BULLETIN NUMBER:
CB11-J-001
ISSUE DATE:
JANUARY 2011

Oil Pipe Gasket Leaking Oil Safety Recall 10V-636

(Transport Canada # TC 2010-459)

Figure 3.

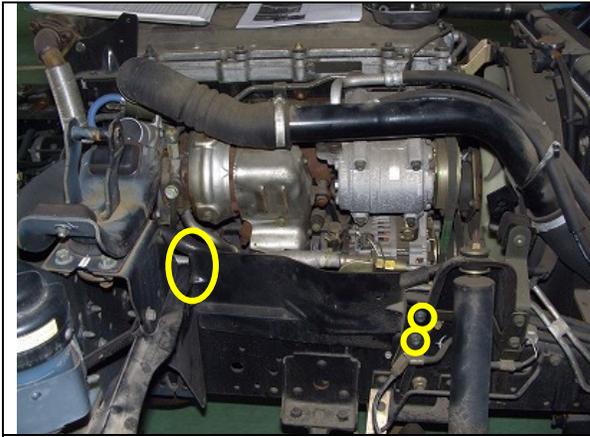
5. Remove the engine side cover. See Figure 3.
6. Remove the turbo heat protector. See Figure 4.

Figure 5.

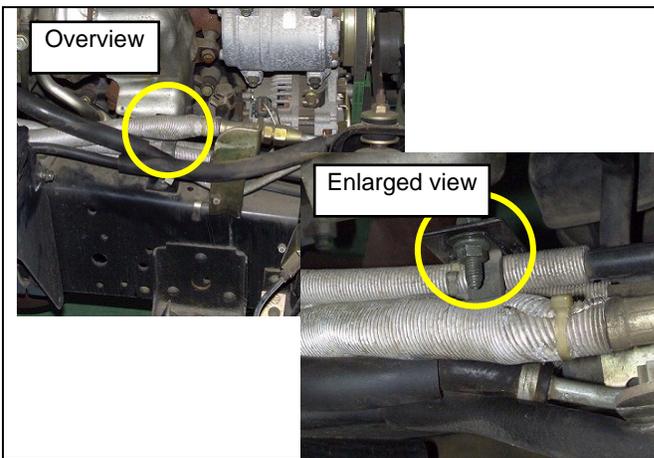
7. Remove the band clip for fastening the shift & select wire. See Figure 5.
8. Remove the bracket for fastening the shift & select wire. See Figure 6.
